NOTICE TO MARINERS No 59 of 2020

Chart Correction - New Breakwater at Il-Qrejten in Il-Port ta' Marsaxlokk

Reference is made to BA Charts 36 – Marsaxlokk

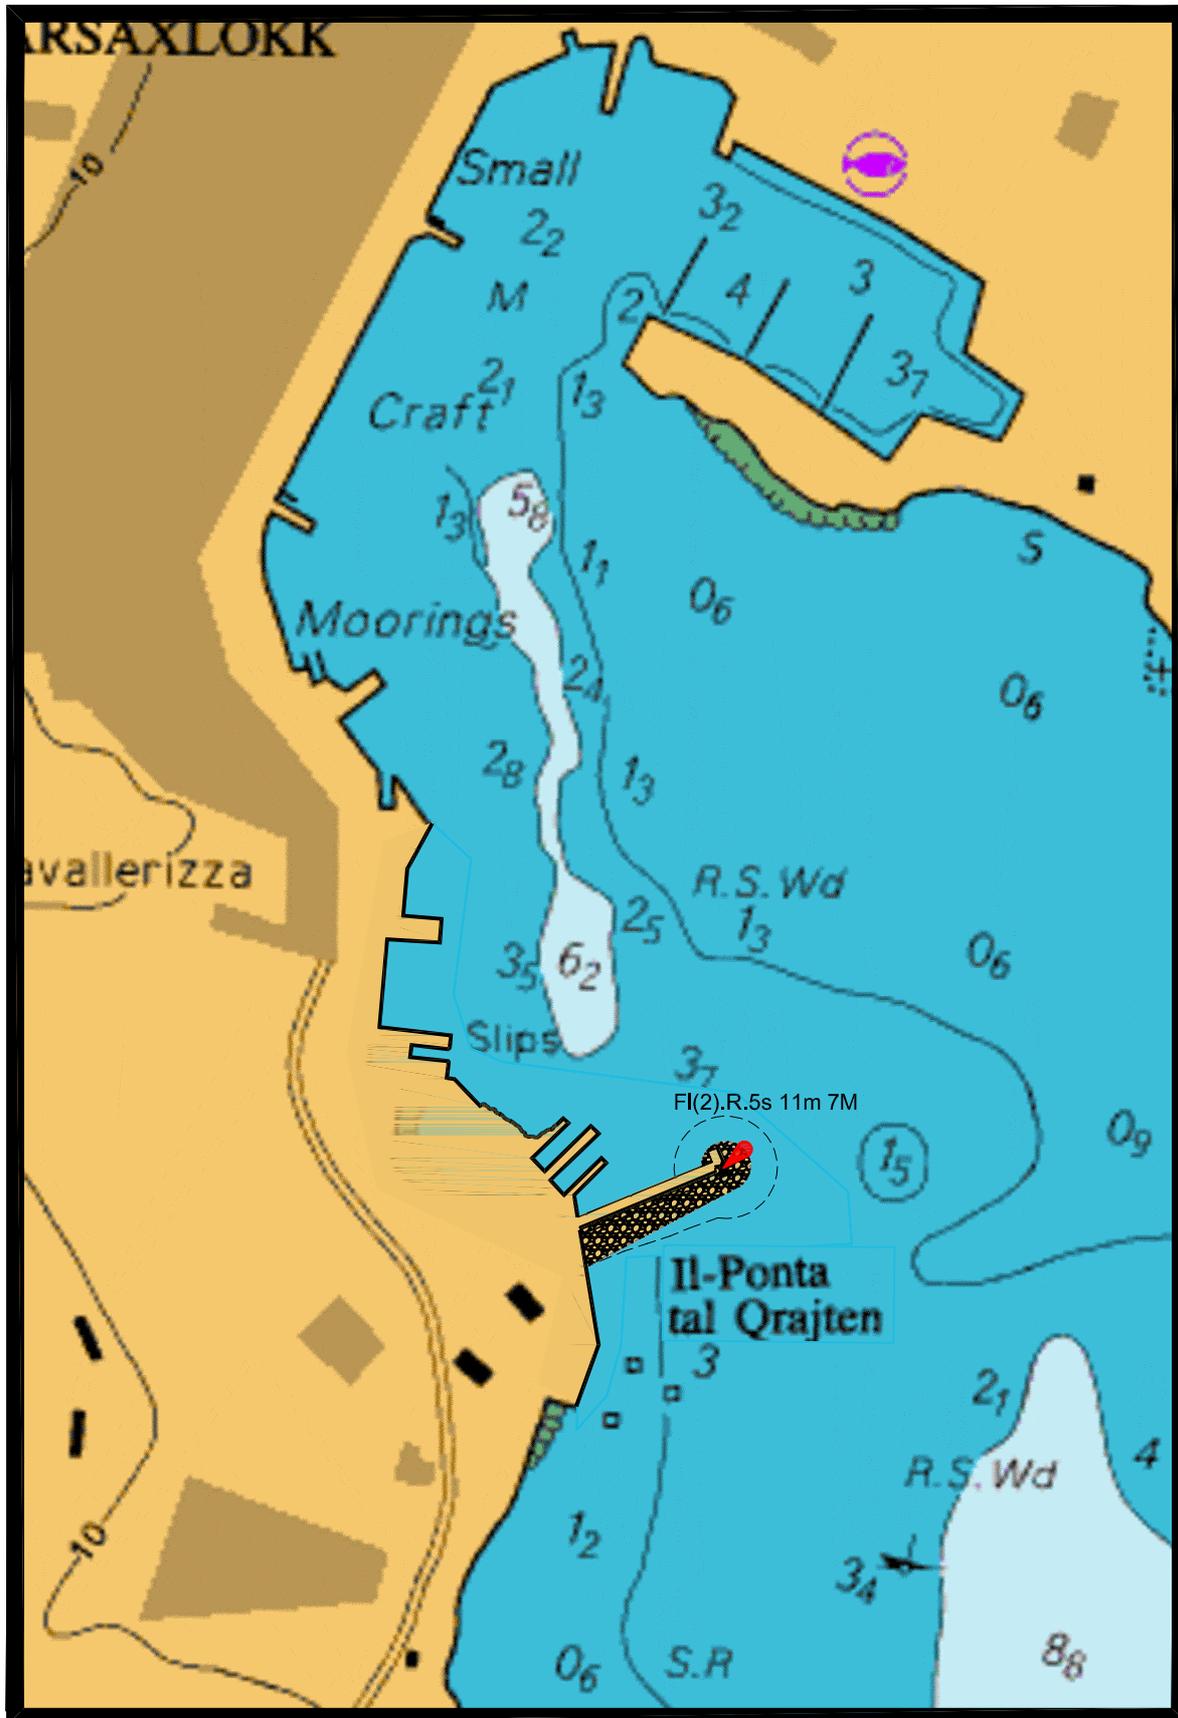
The Ports and Yachting Directorate, Transport Malta notifies Mariners that a new breakwater has been established at Il-Qrejten in Il-Port ta' Marsaxlokk.

The breakwater is formed by joining the following positions and the intermediate coastline as shown on attached chart:

Latitude (N)	Longitude (E)	
from	35° 50'.139	014° 32'.745	Coast
to	35° 50'.155	014° 32'.790	
to	35° 50'.157	014° 32'.788	
to	35° 50'.159	014° 32'.792	
to	35° 50'.153	014° 32'.796	
to	35° 50'.136	014° 32'.746	Coast

Furthermore, a light has been established at the end of the breakwater in the following position

Latitude (N)	Longitude (E)
35° 50'.153	014° 32'.794

The characteristics of the light are: **Fl(2).R.5s 11m 7M**
